**Serial No.: 10/608,828**

**Amendment And Remarks Responsive To**

**Office Action Mailed 03/22/2005**

### **AMENDMENTS TO THE DRAWINGS**

FIG. 3

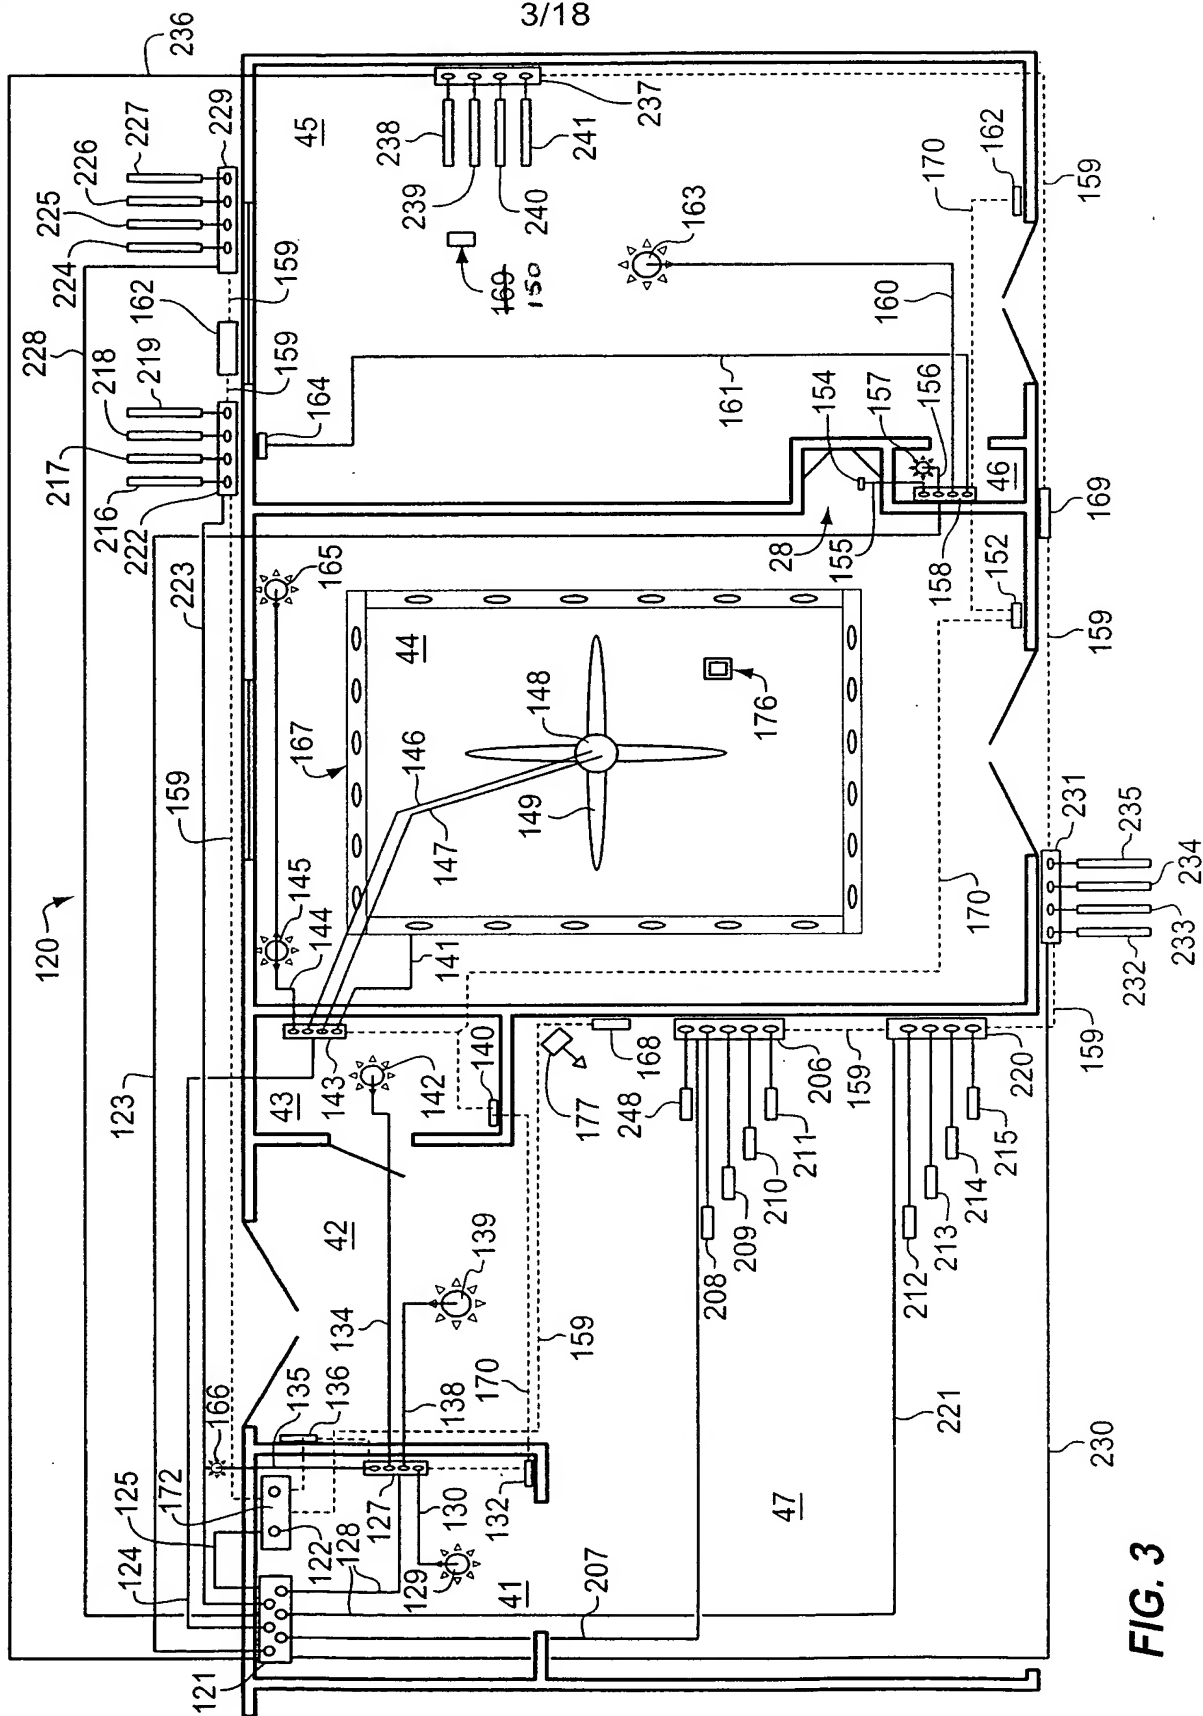
In paragraphs 37 – 39 of the Office Action, the Examiner makes a number of objections to the drawings. The objection relating to the missing reference numbers 150 and 127 have been corrected by amending FIGS. 3 and 7. The objections in paragraph 37 relating to the missing number 101 and 102 and the objections in paragraph 38 have been corrected by changing these numbers to 201 and 202, respectively in the specification. The objections relating to the reference numbers 178, 218, 302, 350, 400, 462, 474, 616, 618, 692, and 694 have been addressed by amending the specification to include these numbers. Please note that the addition to the paragraph starting at page 44, line 14, (Optionally, a SCENE CHANGE PASSWORD screen 616 may be programmed between SCENE button 614 and SCENE CHANGE screen 618) is simply wording taken from page 45, lines 10 – 13, adapted to what is shown in FIG. 22B for the numerals 616 and 618, and therefore is not new matter. Also note the addition to the paragraph starting on page 48, line 27, (from which a linkage can be added at 692 or deleted at 694) merely reflects what is shown in FIG. 22B, and thus is not new matter.

The corrections to FIGS. 3 and 8 as cited by the Examiner on page 16, paragraph 37, of the Office Action have been made and corrected Formal Drawings are attached hereto.
